Customer	: CU-DAR001 Dart Helicopters Services	Drawing Name	: SHOULDER HARNESS KIT
Job Number	: 29695		
Estimate Number	: 12540		
P.O. Number	: N/A	Part Number	: DSI9351013
This Issue	: 11/27/2006 S.O. No. : N/A	Drawing Number	: DSI9351 REV A
Prsht Rev.	: NC	Project Number	: N/A
First Issue	: MA Type : SMALL /MED FAB	Drawing Revision	: A
Previous Run	: 29649	Material	: N/A
Written By	: <u>JA</u>	Due Date	: 11/29/2006 Qty: 5 Um: Each
Checked & Approved By	: <u>JA 06 11 27</u>		
Comment	: Est Rev:A New Issue 06-09-27 JLM

DESIGN <i>LE</i>	DRAWN BY <i>LE</i>	DART AEROSPACE LTD HAWKESBURY, ONTARIO, CANADA	
CHECKED <i>GP</i>	APPROVED <i>[Signature]</i>	DRAWING NO. DSI 9351	REV. A SHEET 1 OF 1
DATE 06.09.15		TITLE SHOULDER HARNESS KIT SCALE NTS	
REV A	DATE 06.09.15	DESCRIPTION NEW ISSUE

DART SERVICE INSTRUCTION

TO AMEND INSTALLATION INSTRUCTIONS IIN-D412-702 REV A, B OR C
REF. CANADIAN STC SH04-7
REF. FAA STC SR01997NY

DETAIL A
SCALE 4:1

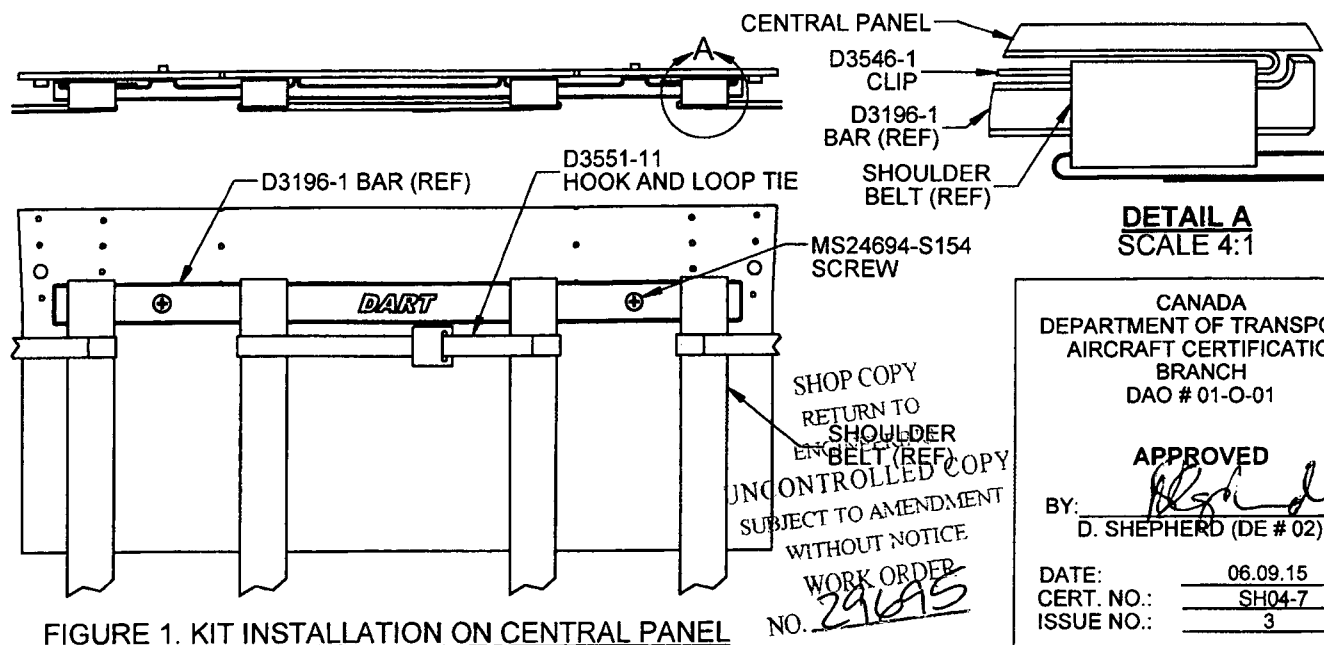
TO IMPROVE THE FIT AND VISUAL IDENTIFICATION OF SHOULDER HARNESS SETS, DSI 9351-011/-013/-015 SHOULDER HARNESS UPGRADE KITS ARE AVAILABLE FOR THE D412-702-011/-021/-013/-023/-015/-025/-017/-027 AND D214-702-035 SHOULDER HARNESS KITS AT CHANGE 1. INSTALLATION OF THESE KITS IS OPTIONAL.

1) REMOVE THE MS24694-S152 SCREWS FROM THE D3196-1 BAR ON THE CENTRAL PANEL. RE-INSTALL THE D3196-1 BAR WITH D3546-1 CLIPS USING MS24694-S154 SCREWS AS SHOWN IN FIGURE 1. ENSURE THAT THE SHOULDER BELTS ARE LOOPED THROUGH THE CLIP AS SHOWN IN DETAIL 'A'. TORQUE SCREWS TO 100-140 in-lbs (11.3-15.8 N-m). IT IS ACCEPTABLE TO USE LONGER MS24694-SXXX SCREWS AS REQUIRED TO ENSURE THAT THE D3196-1 BAR IS PROPERLY SECURED.

2) INSTALL THE D3551-11 HOOK AND LOOP TIES THROUGH THE FRONT LOOPS OF EACH SET OF SHOULDER BELTS. INSTALLATION ON THE 4-MAN AFT FACING BENCH IS AT THE DISCRETION OF THE INSTALLER. ENSURE THAT THE 'LOOP' SIDES OF THE TIES ARE FACING OUTWARD FOR PASSENGER COMFORT. TIGHTEN OR LOOSEN THE TIES AS NEEDED (TRIMMING IS ACCEPTABLE).
